SAFETY RECALL

Mack Trucks Inc.
Greensboro, NC USA

Release Date	Number	Release	Page
02.2024	SC0457	01	1(5)

Sheppard Steering Gear AN, GR, LR, LRBE, PI, TE

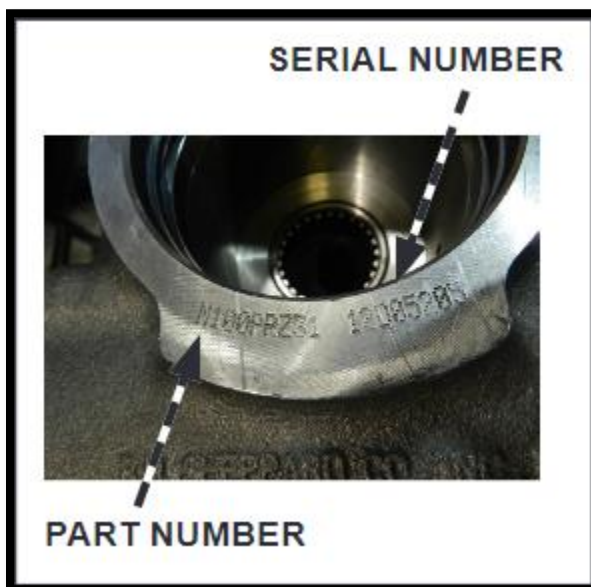
1. Secure vehicle for service.
2. Place the transmission in park or neutral.
3. Install wheel chocks.
4. Unlatch and raise the hood.
5. Locate the Sheppard steering gear serial number following the instructions below.
 - There are two different steering gear box configurations. (See below)

It is not necessary to remove the steering gear box to locate the serial number.

6. In some configurations the serial number is between the steering gear and the frame. It may be necessary to turn the wheels, so the pitman arm moves out of the way.
